## Staff Report to the Planning Commission

Application Number: **08-0332**

**Project Description:** Proposal to divide an existing parcel into two parcels, convert one dwelling of an existing two unit dwelling group to a second unit with a habitable accessory structure on the second story, and construct one new single-family dwelling. Requires a Minor Land Division, Residential Development Permit, and a Variance to reduce the required parcel frontage and width from 60 feet to approximately 55 feet, required front yard setback from 20 feet to 10 feet, required street side yard from 20 feet to 10 feet, and a Roadway Roadside Exception to reduce the required 56 foot right of way to a 20 foot right-of-way.

3D SIMULATION  
N.T.S.

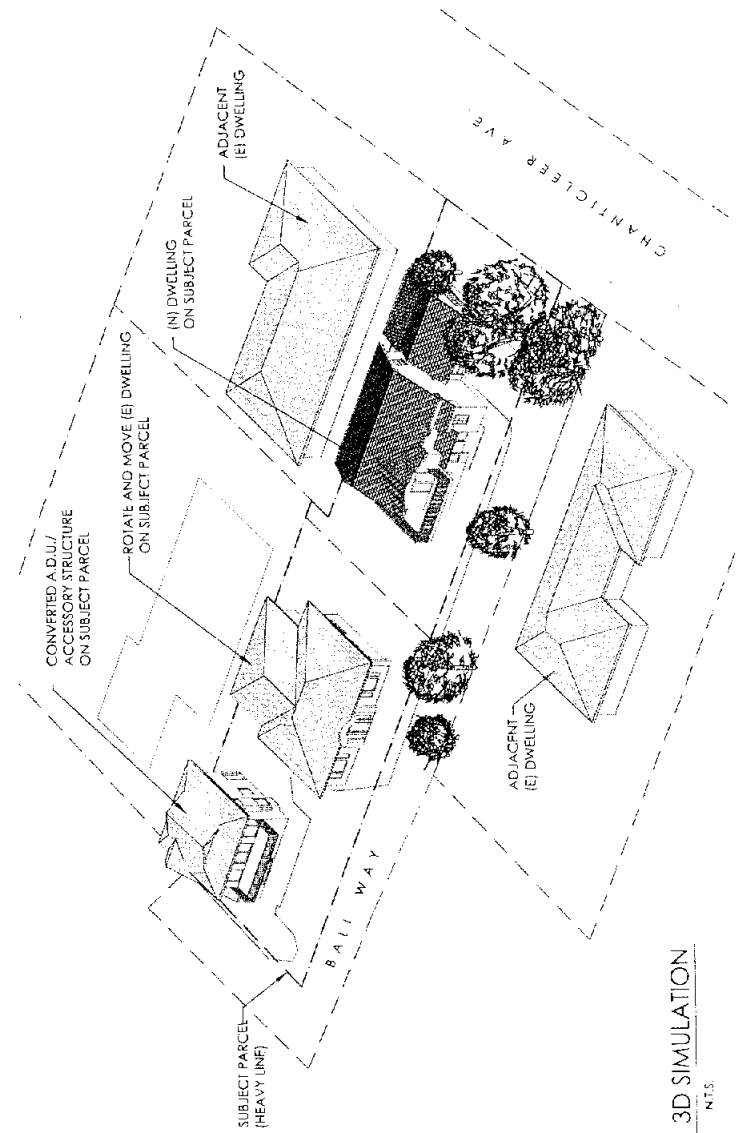
- c. Please revise the 3D simulation on Sheet A1 to show the entry of the existing residence facing Bali Way. (Urban Designer – Larry Kasparowitz 454-2676)

Tentative Map - Minor Land Division

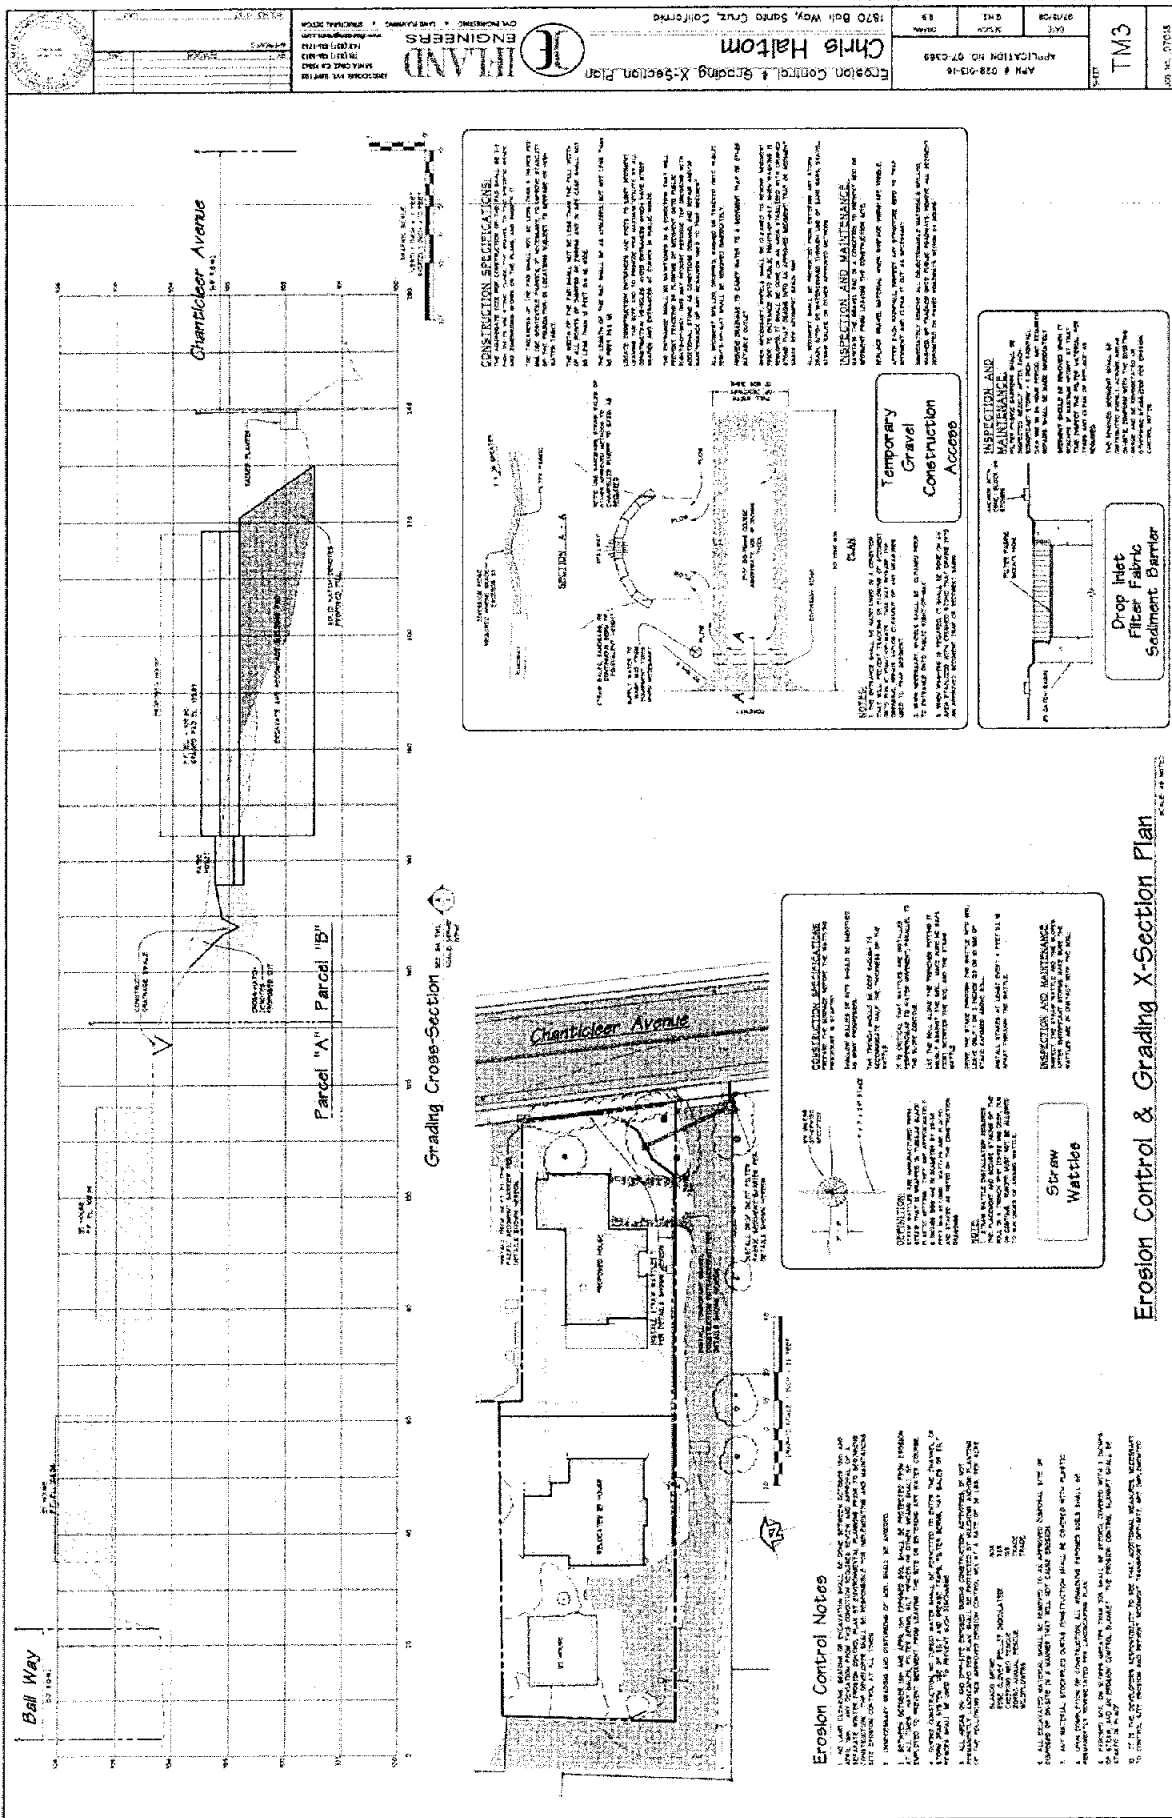
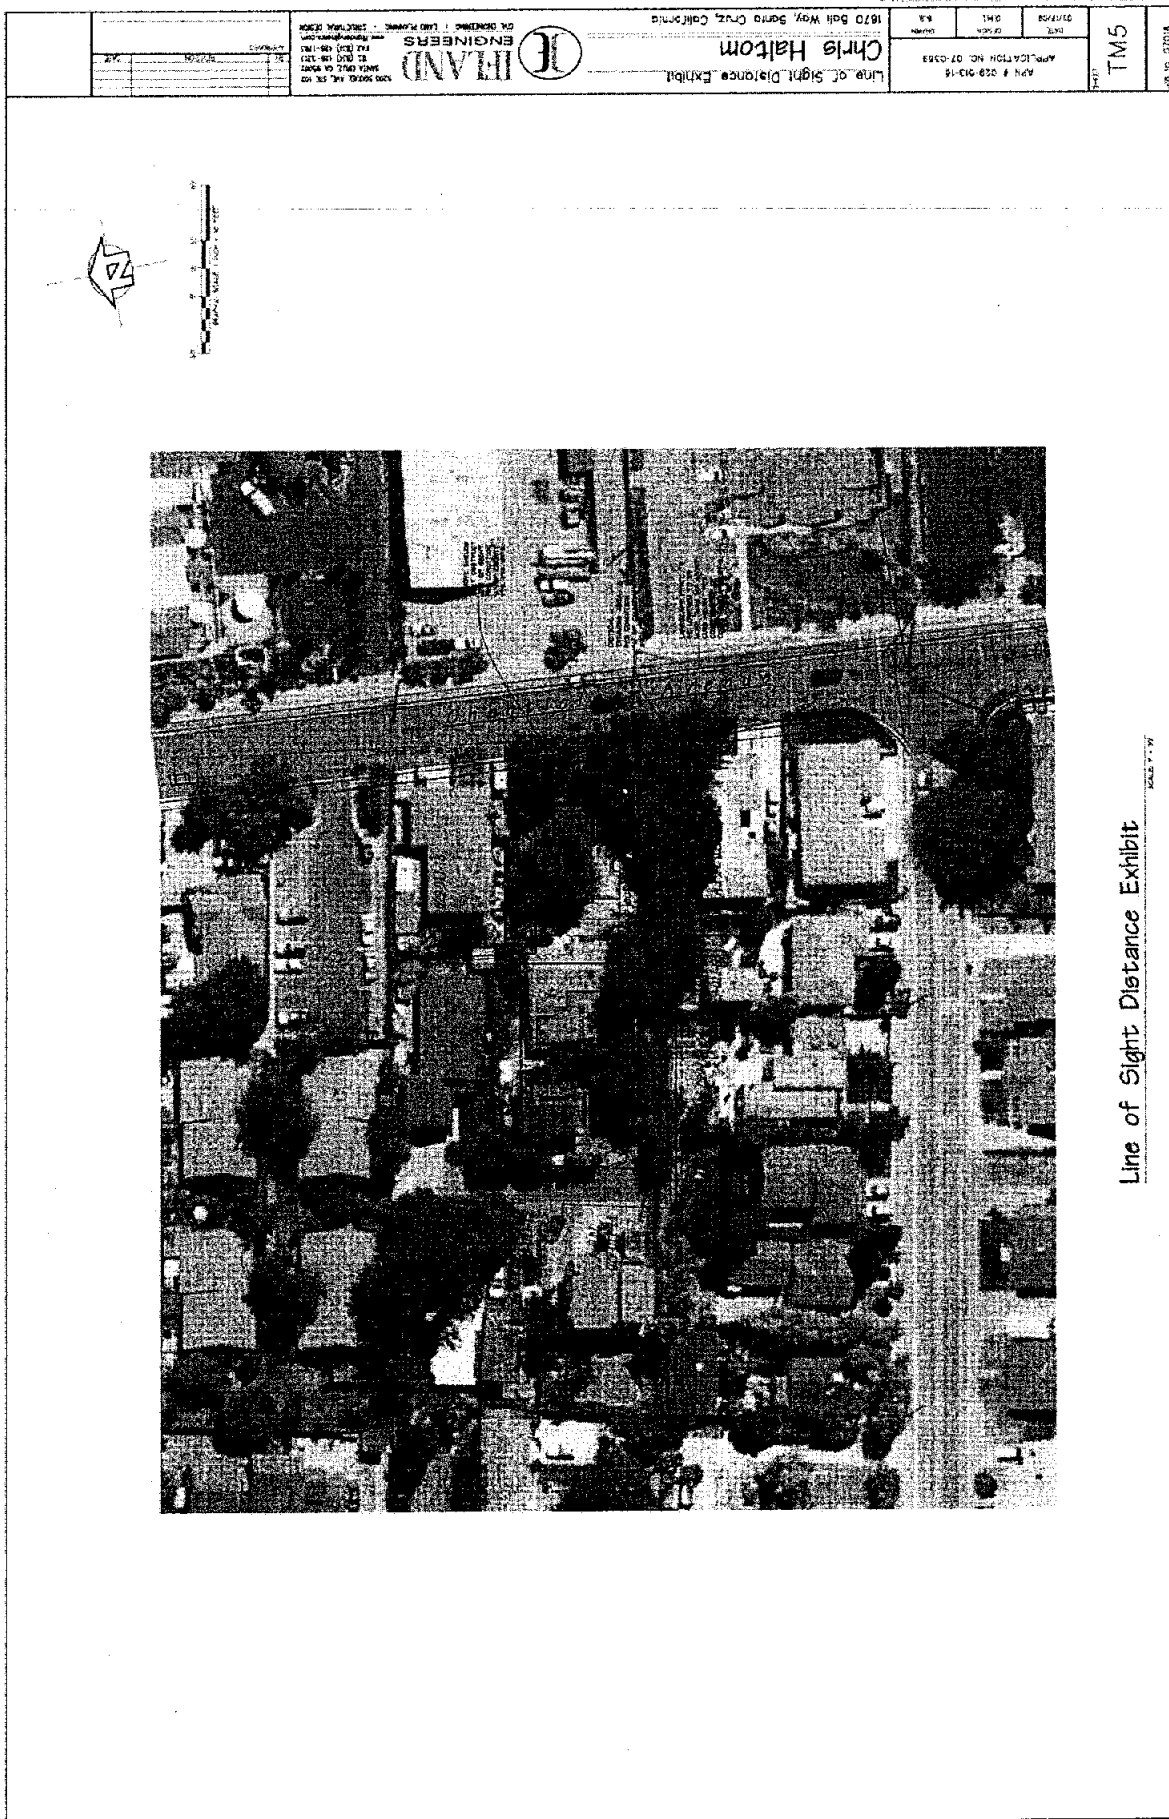
2. According to the grading cross section on sheet TM3 the existing storm drainage ponding area (proposed detention area?) is partial within a fill slope. The cross section also indicates that the existing grade at the base of the fill slope is 101.5 while the site plan shows the proposed detention system outlet grate elevation at 101.5. If these elevations are correct the detention area being provided would be significantly less than 400 cubic feet that the plans suggest is be proposed. Please clarify and revise.

1) County inventory indicates differing stormdrain facilities along Chanticleer Avenue than what is shown on the submitted plans. While some information on sheet TM2 has been updated, information on sheet TM1 has not. There are two storm drain lines shown on the eastern side of Chanticleer, is this accurate? Please review and provide correct representation on the plans as needed.

2) Section A-A on sheet TM3 shows a graded swale in the same location as sheet TM2 shows an improved patio area. Please review and clarify.

1. County inventory indicates differing stormdrain facilities along Chanticleer Avenue than what is shown on the submitted plans. While some information on sheet TM2 has been updated, information on sheet TM1 has not. There are two storm drain lines shown on the eastern side of Chanticleer, is this accurate? Please review and provide correct representation on the plans as needed.

2. Section A-A on sheet TM3 shows a graded swale in the same location as sheet TM2 shows an improved patio area. Please review and clarify.

1. Provide bearing of proposed property line on sheet TM1.
2. Show existing contours a minimum of 50 feet beyond project boundary.
3. The Department of Public Works will not approve the Improvement Plans until final approval by a certified arborist has been provided for installation of a storm drain line between two 30" Cypress trees to remain.
4. Provide a tree protection plan.
5. Drainage structure will be required at connection point of new storm drainage line and existing storm drainage line on Chanticleer Avenue.
6. Fill wedge shown on sheet TM3 will interfere with existing 24" redwood tree to remain and will encroach into existing storm drainage pond. Please clarify.
